mcHF Hardware modifications as of October 28, 2014 as compiled by KA7OEI for Revision 0.3 boards

The 4.7 ohm resistor added to the UI_8V line feeding U2, the audio amplifier.

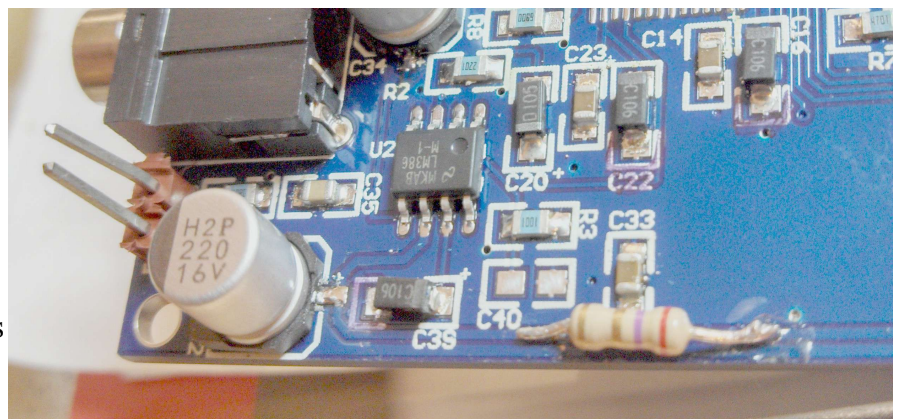
The insertion of a 4.7 ohm, 1/2 watt resistor in series (or two 10 ohm 1/8 watt resistors in parallel) with the +8 volt line, near the LM386 audio amplifier.

This is an important modification that fixes one source of oscillation at high volume levels.

This modification prevents audio from appearing on the 8 volt line which, in turn, causes audio to appear on the ground busses and other power supplies in the radio which can cause feedback, particularly at high volume levels with wider audio filters.

The "U3a" modification, piggybacking another 74HC4066 atop U3 to prevent feedback into the receiver.

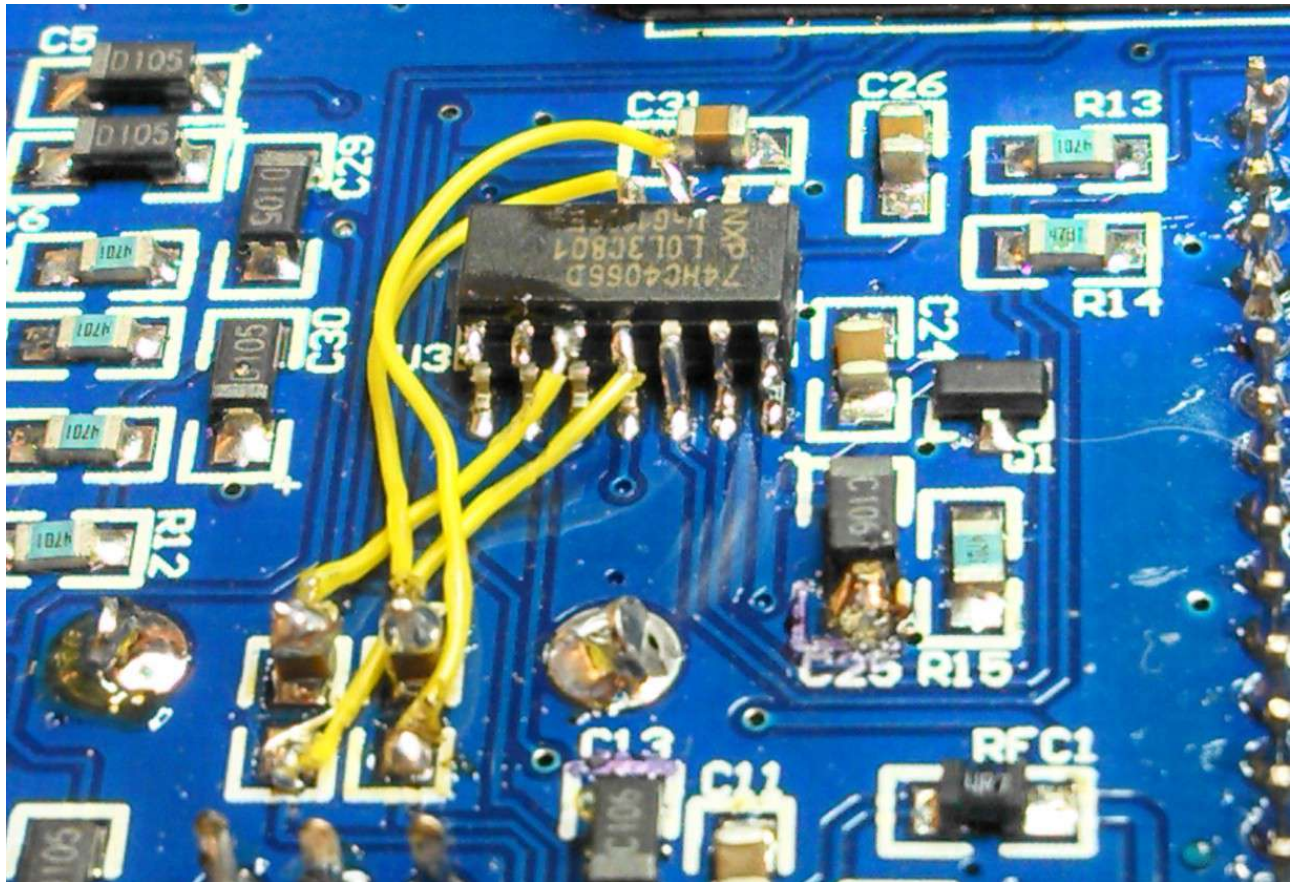
The installation of "U3a", a 74HC4066 switch, piggybacked atop U3 - a pretty easy mod, once you have soldered the rest of the board. This fixes a source of distortion/oscillation in the receiver, particularly at high volume levels and on high bands. The chip for "U3a" is the same type as U3.

Take a 74HC4066 chip, of the same type and package as U3 and piggyback it atop U3 (on the UI board) and use its power supply and control signals. This chip will now be able to turn on/off the TX I and Q signals with a bit of fairly simple rewiring. Let us call this new chip "U3a"

- Using a VERY FINE tip, solder pin 14 of U3a to pin 14 of U3.
- Align pin 7 of U3a to U3 and solder.
- Now solder pins 5, 6, 12 and 13 of U3a to U3.
- Remove capacitors C7 and C8 and stand them on end, attaching them to the pad closest to U3, the upper pad. This will leave the lower pads of C7 and C8 empty. You can turn C7 and C8 around, the “open” end facing U3 rather than mounting them on end, if you prefer.

- Using fine-gauge wire such as #30 AWG wire-wrap wire, run leads to sections 1 and 4 of U3a. For example, the wires connecting across the connection of C8 would go to pins 1 and 2 of U3a and the connection of C7 would go to pins 10 and 11 of U3a. Which wire goes to which side of the switch does not matter, nor does which connection goes to which switch.

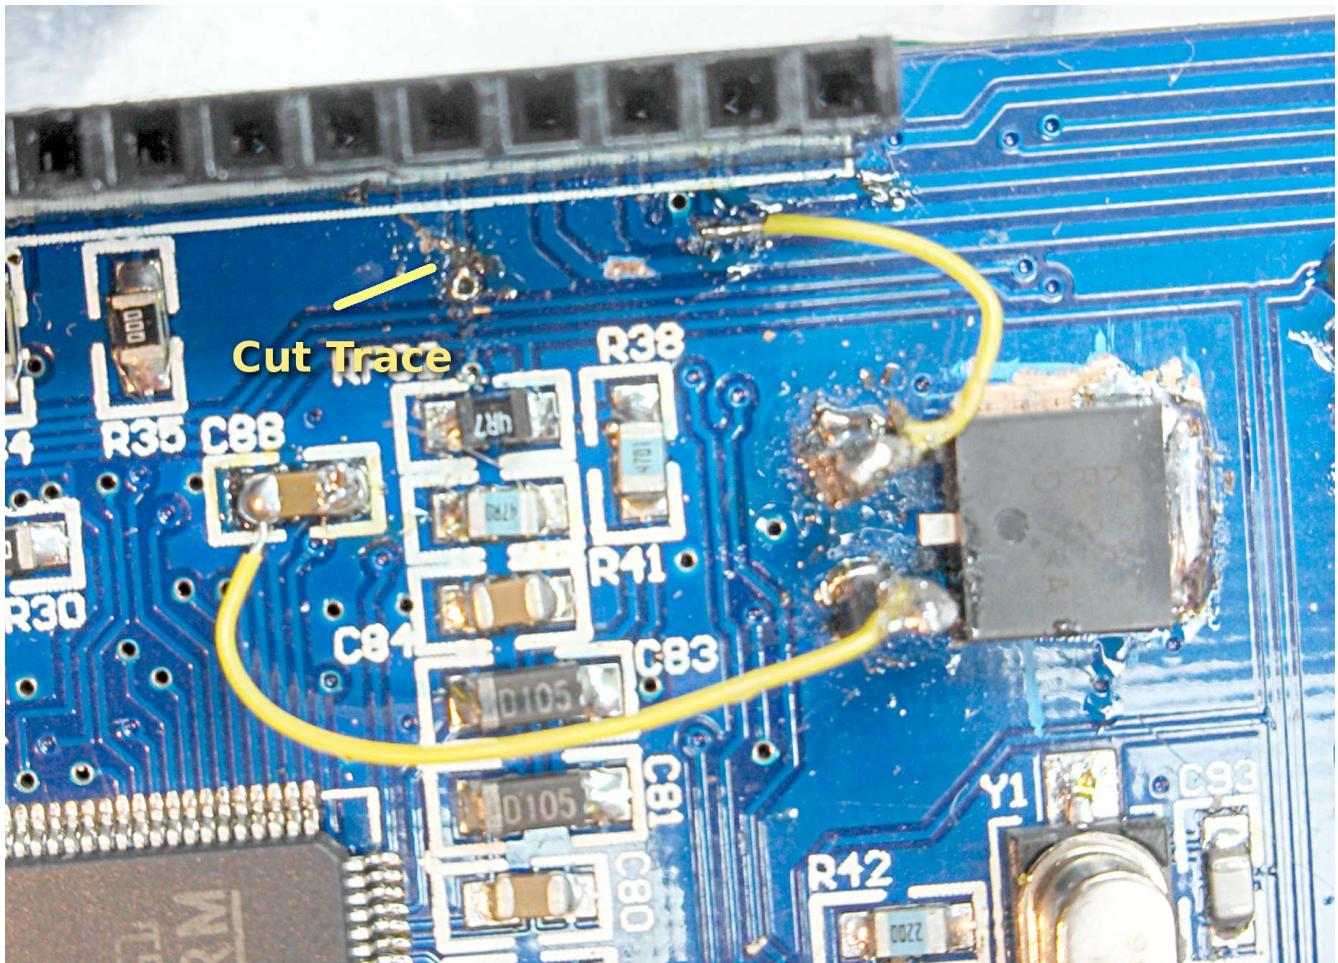
Note that the other two sections of "U3a" (2 and 3) are connected to the inversion logic (Q1 on the UI board) and are active when in receive mode and the corresponding I/O pins (pins 3, 4 and 8,9) are left floating (which will cause no problems on a '4066) - but these may be useful for something else...

This modification prevents “breakthrough” of the TX QSD mixer (U17) caused by the fact that the Codec's DA is shared both for RX audio and TX modulation. Because the audio drivers for the TX modulator (U20-U23) are powered from 8 volts it is possible for high RX level audio to violate logic levels at U17, turning it “on” on voltage peaks: The result of this is highly-distorted, on-frequency noise/feedback.

This picture shows the location of the traces and where the cuts should be made. This is found to the right and above U4a, the MCU. A picture of a “bare” board is used for clarity.

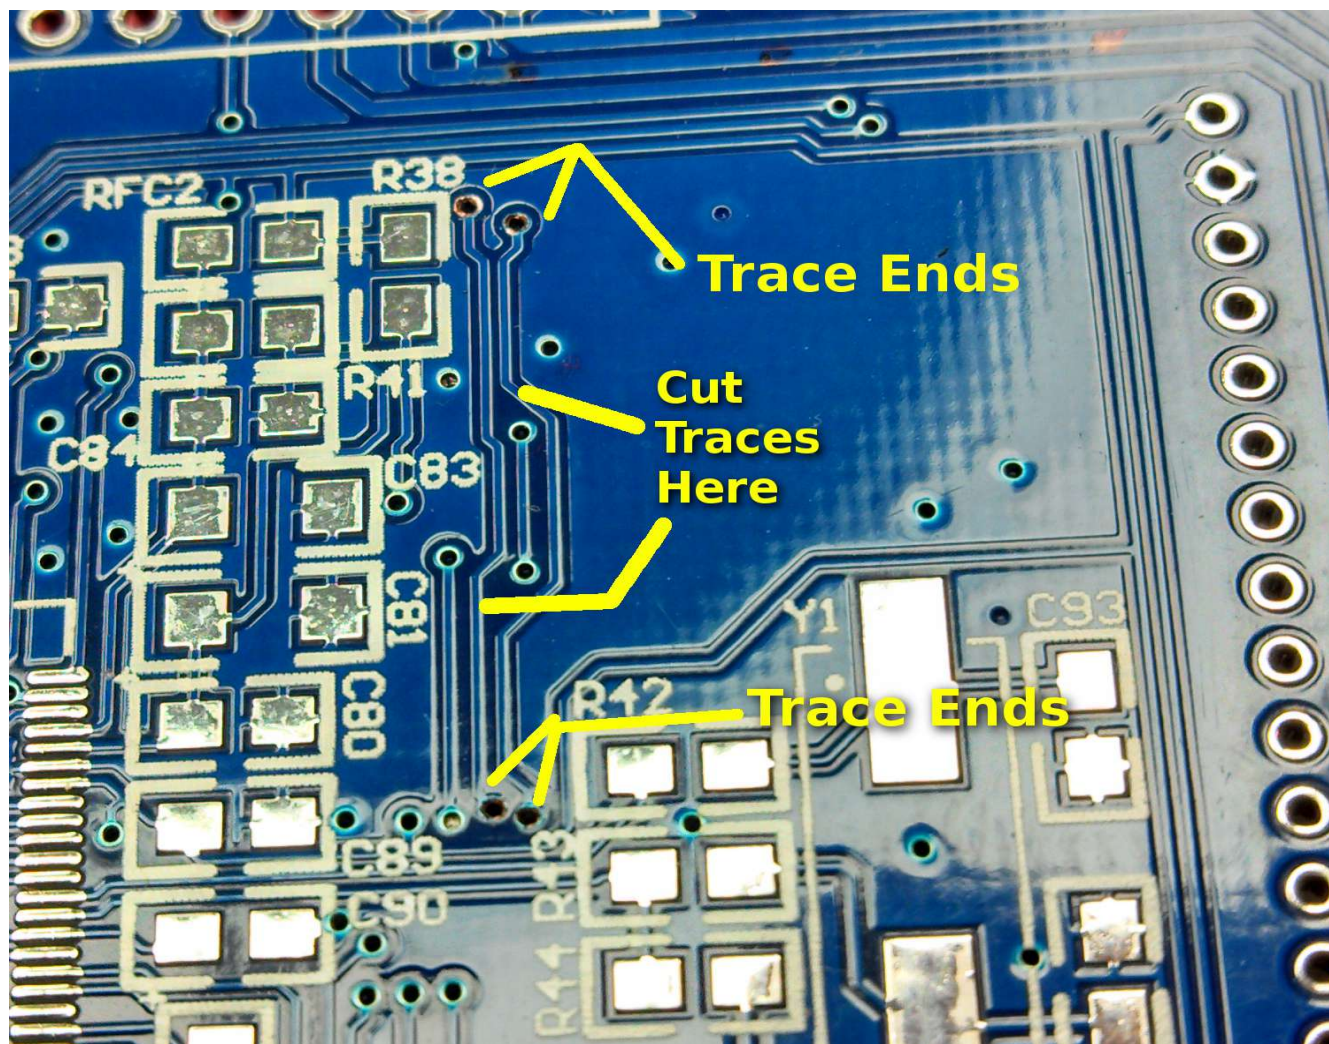
If the above modifications are made, with no antenna connected – or even with an antenna connected when listening on higher bands (especially 20 meters and above) a fairly strong “tick” may be heard every second. This is due to the polling of the onboard temperature sensor and the fact that the “fall” time of the on the I2C line from the MCU is extremely fast and rich with harmonic energy. This problem can be easily “fixed” with the addition of resistors on the UI board in series with the SCL and SDA lines which effectively reduce the slew rate of these lines, quashing the RF energy.

To identify the traces into which the resistors are to be installed, refer to the picture below:

A reasonable value of resistor to install is 470 ohms and the installed components may be seen in the picture.

The added 470 ohm resistors in series with the SCL and SDA lines. Note that this picture also shows the added 3.3 volt MCU regulator mentioned above. 1/8 watt, leaded resistors are used, but surface mount resistors could be used, if desired.

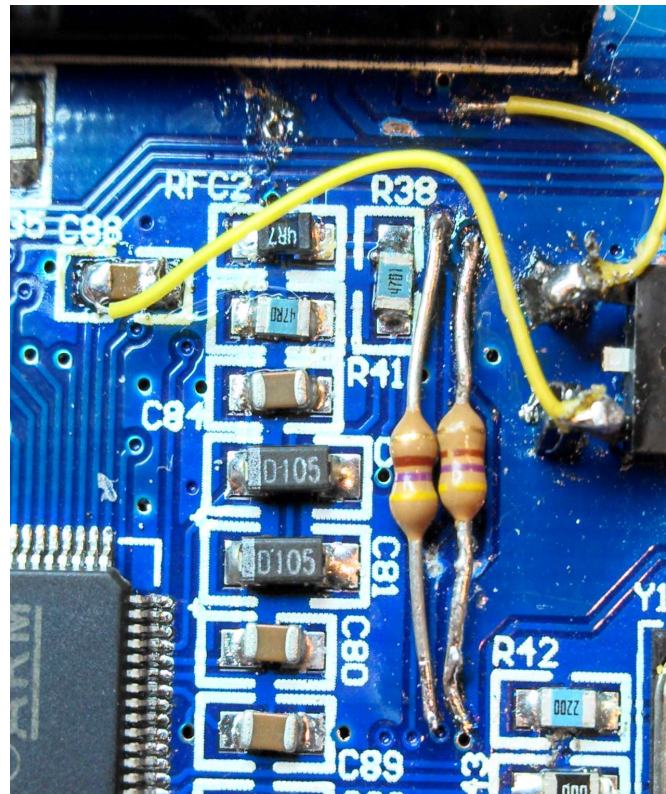
In the picture can be seen the two added 470 ohm resistors. As you can see, I used leaded 1/8 watt resistors, but surface mount resistors can be used, instead if that is your preference. (The 3.3 volt regulator used for the MCU – see the modification earlier in this document – can be partially seen.)

This modification appears to be *completely* effective in removing the “tick” noise from the higher bands and does not appear to compromise the operation of the I2C data stream in any way.

Of the rise and fall times on the I2C, the slowest slew rate was the rise time shown in this digital oscilloscope capture, which is well within the acceptable time for the clocking rate!

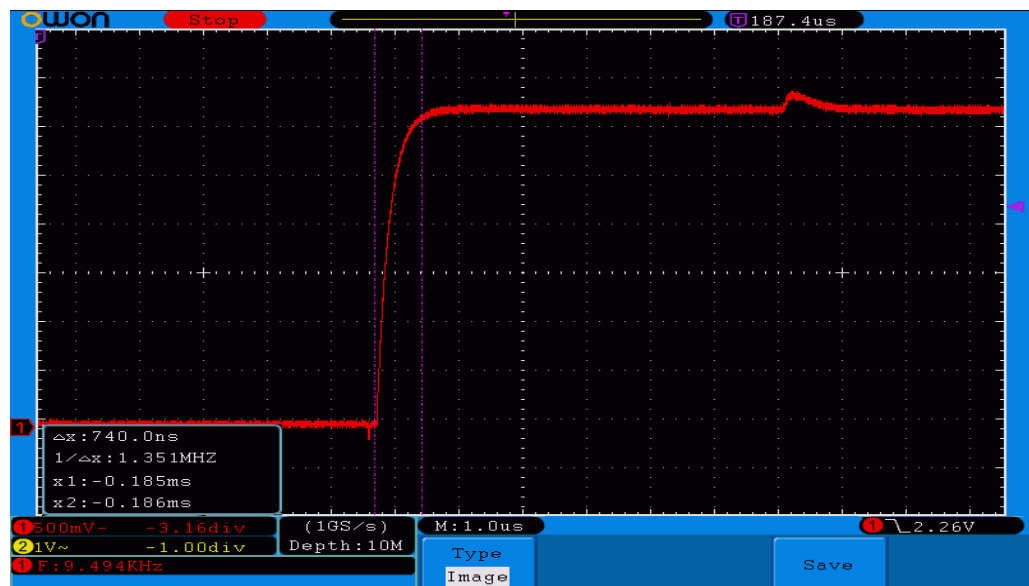
To verify the integrity of the I2C data stream – which is shared with the Si570 frequency synthesizer – I monitored the data stream with a digital storage oscilloscope and measured the worst-case slew rate – which was actually the risetime - the result being noted below.

As can be seen, the risetime is less than 740 ns at the 10%-90% points which is a fraction of the I2C clocking rate, well within the time at which the edge of the clock into which the data is strobed in by the peripheral.
